Carolina Power & Light Company

February 24, 1975

H. B. ROBINSON UNIT NO. 2
LICENSE DPR-23
CORRECTION OF SUBMITTED DATA IN
SECOND REFUELING OUTAGE SUMMARY REPORT

Figure 3

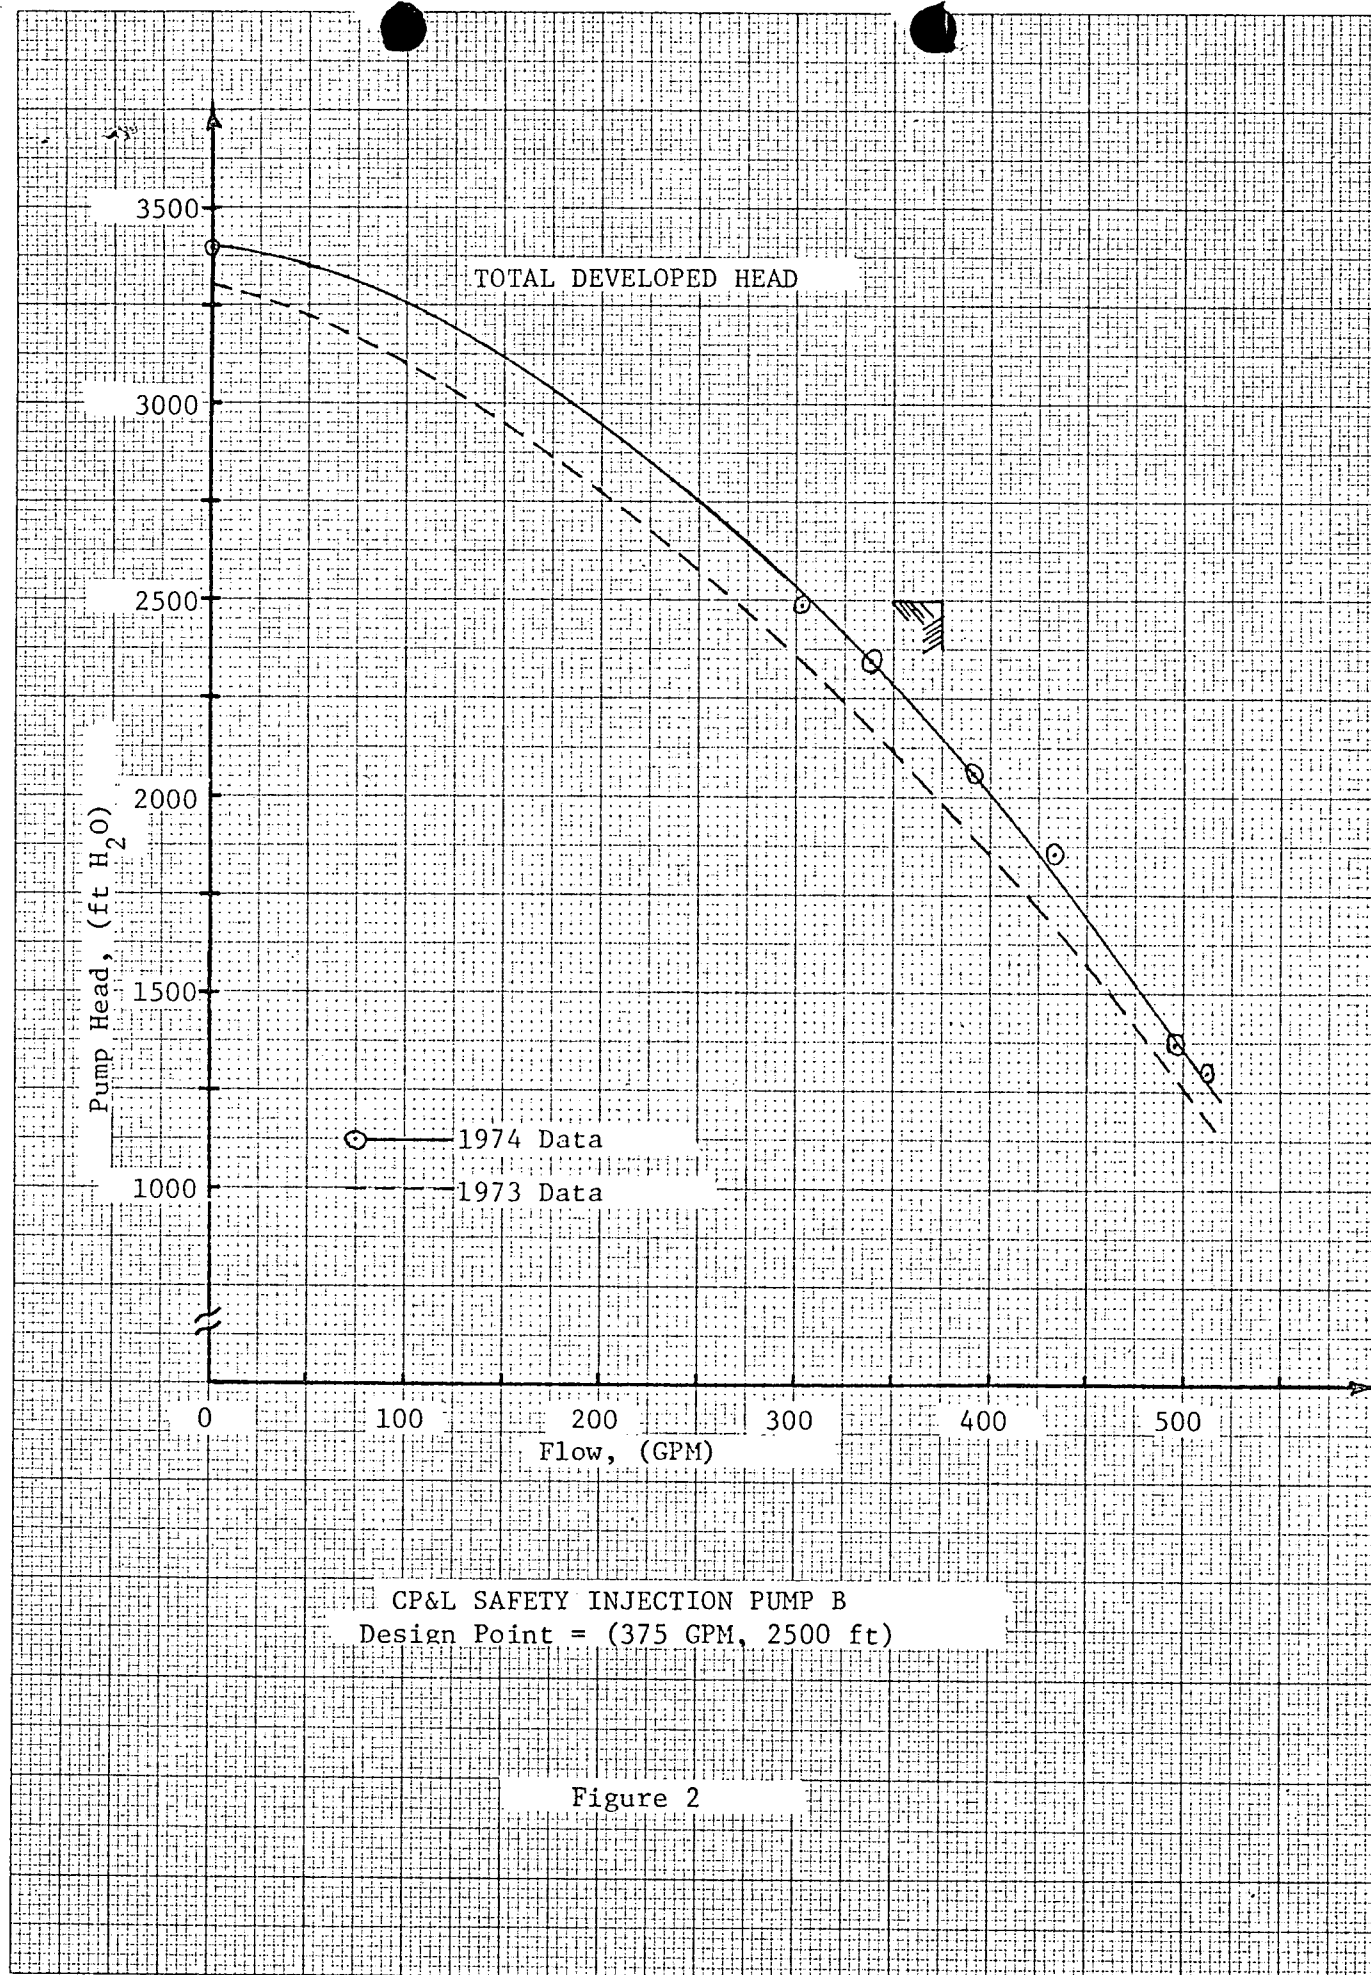
On October 7, 1974, Carolina Power & Light Company submitted a report entitled "H. B. Robinson Unit No. 2 - Second Refueling Outage - Summary of Events of Interest," which was provided at the request of the Directorate of Regulatory Operations. During subsequent inspection of figures included in the report, it was discovered that several graphs pertaining to safety injection system performance were deficient in that values of the ordinates and abscissas were missing or erroneously labeled. To correct this deficiency, we hereby submit revised Figures 1 through 4 of the subject report with the proper information.

Figure 4
INJECTION TO
REACTOR COOLANT SYSTEM

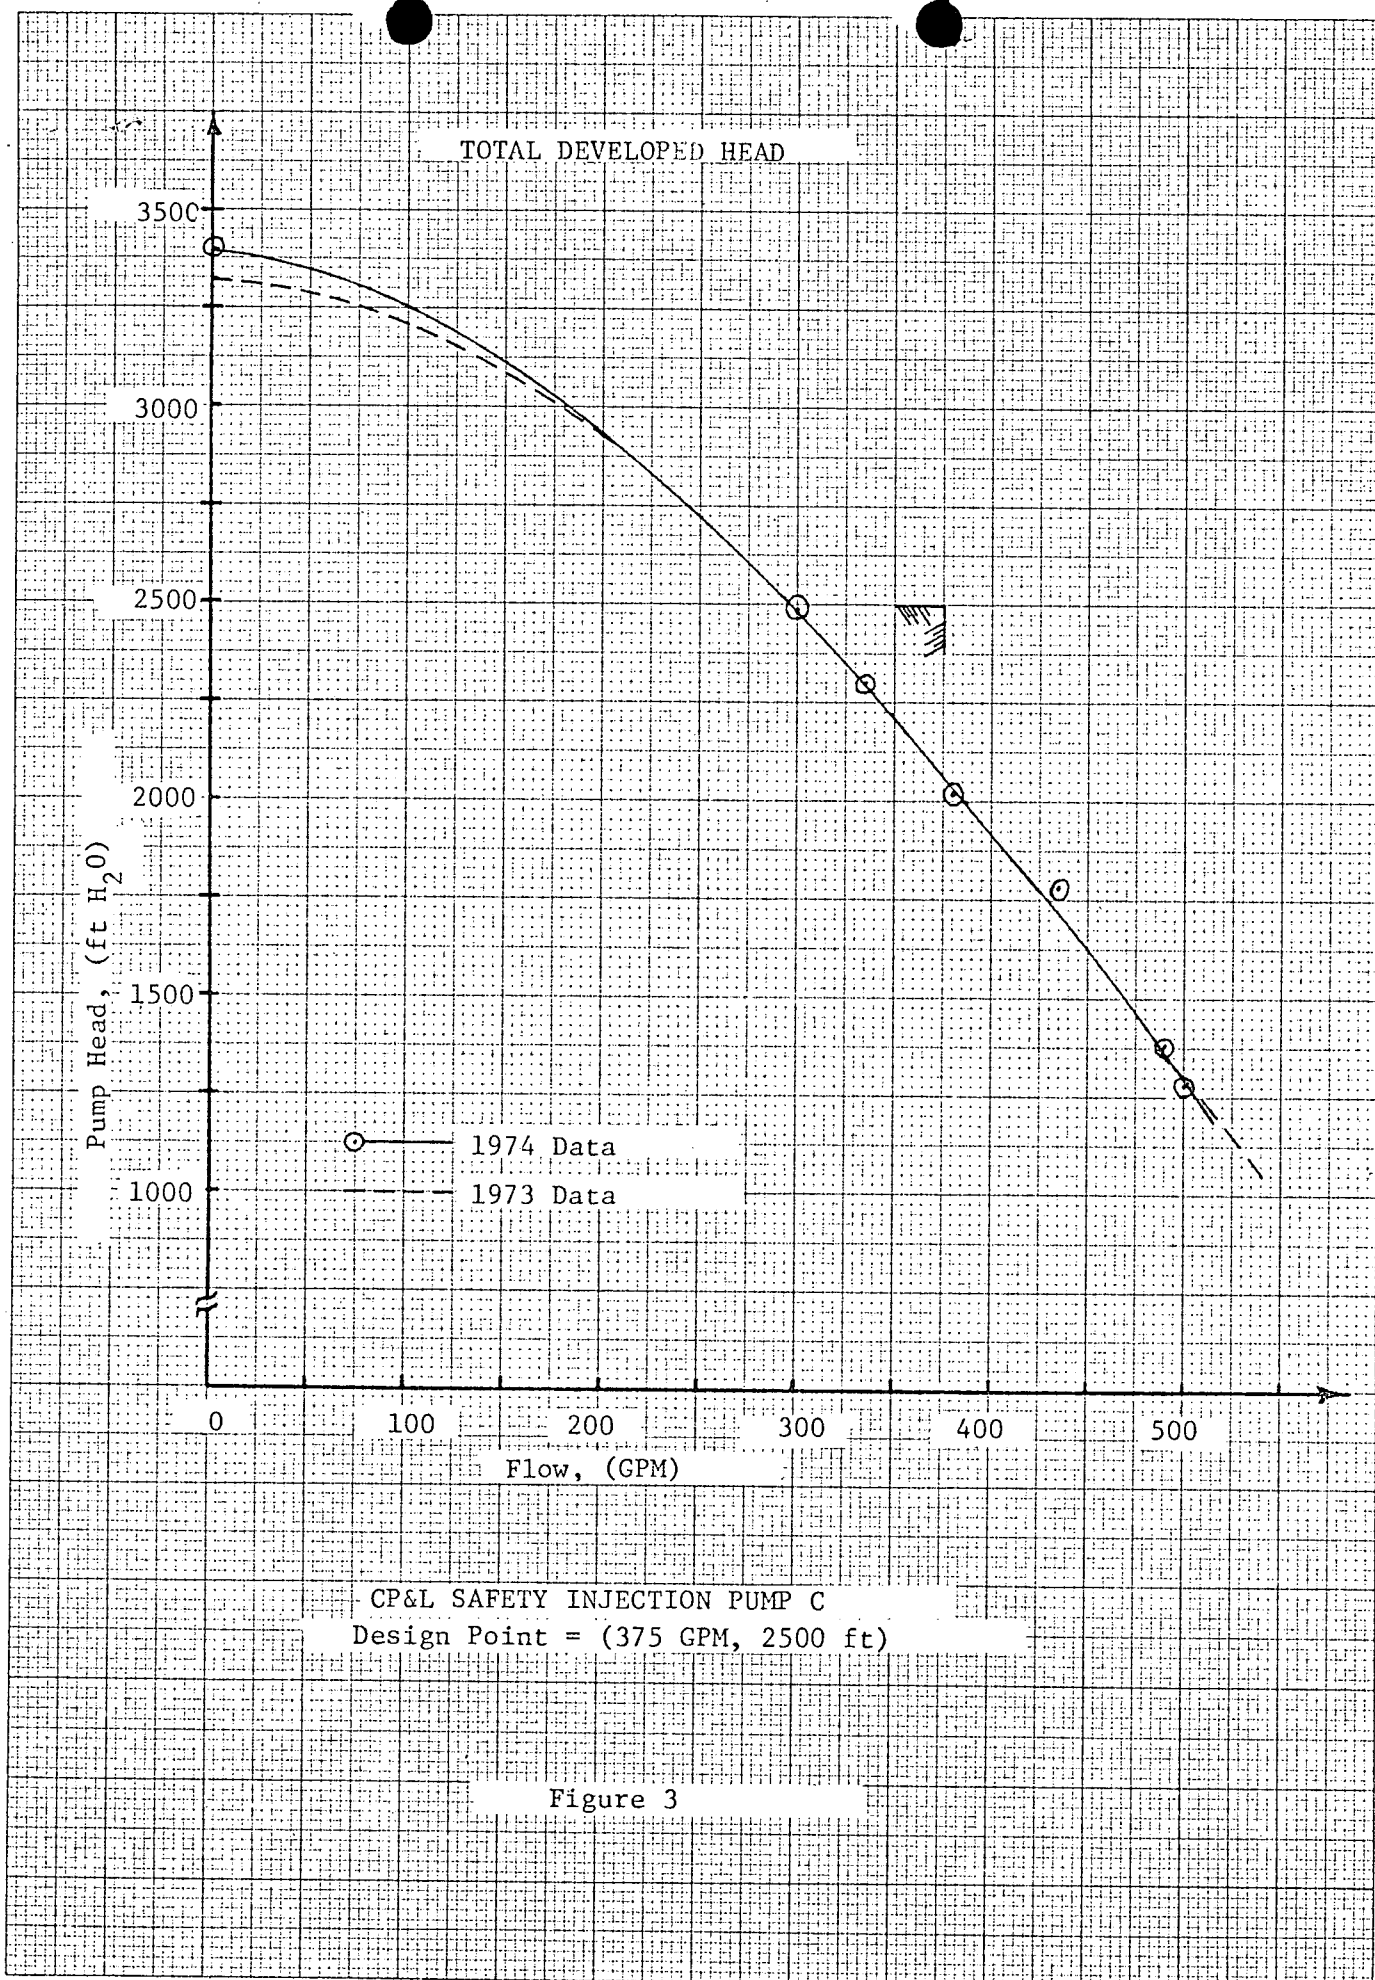
In addition, we have added an additional system delivery curve to Figure 4, Injection to Reactor Coolant System, to show the degraded delivery for the LOCA sensitivity analysis presented in our submittals of September 7, 1973 and January 4, 1974. You should replace the original figures in your copies of the October 7, 1974 report with the figures in this submittal.
